SERVICE INFORMATION

LAND-ROVER PETROL AND DIESEL MODELS

Vol. 1 No. 6

August, 1972

Fig. 1 Correct location of solenoid feed wire

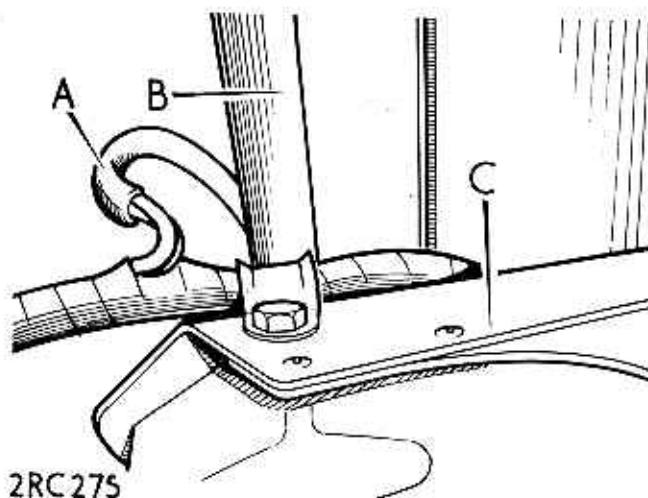
MODIFICATION: Introduction of modified main harness to prevent a foul condition between air cleaner, harness and wing valance.

It has been brought to our attention that in certain instances a 'foul' condition may be present between the air cleaner, main harness assembly and the right hand side wing valance.

Service personnel are requested to examine all earlier vehicles, during routine maintenance checks and, if required, peel back the non-adhesive harness binding tape, thus allowing the solenoid feed wire to be re-routed away from the obstruction.

Should the solenoid feed wire be badly chafed, it should be replaced with the modified main harness assembly.

Fig. 2 Identification of ignition lead

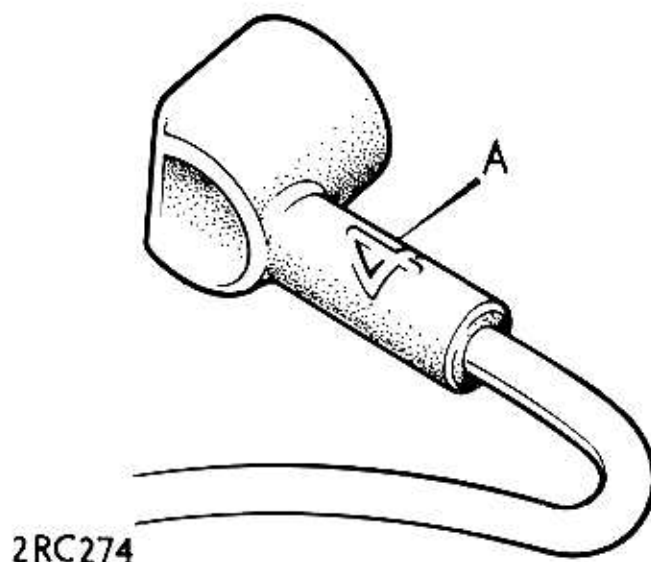
Several cases of engine misfire, and poor starting under wet or damp conditions have been reported and investigation has shown this to be caused by poor moulding of the right angled coil boot on the coil to distributor high tension ignition lead.

If this condition is detected or brought to your attention by an owner, on vehicles sold during the last 12 months, then the coil to ignition lead must be changed for the modified type, which has a moulding number stamped on the right angled coil boot. The earlier type has no moulding number.
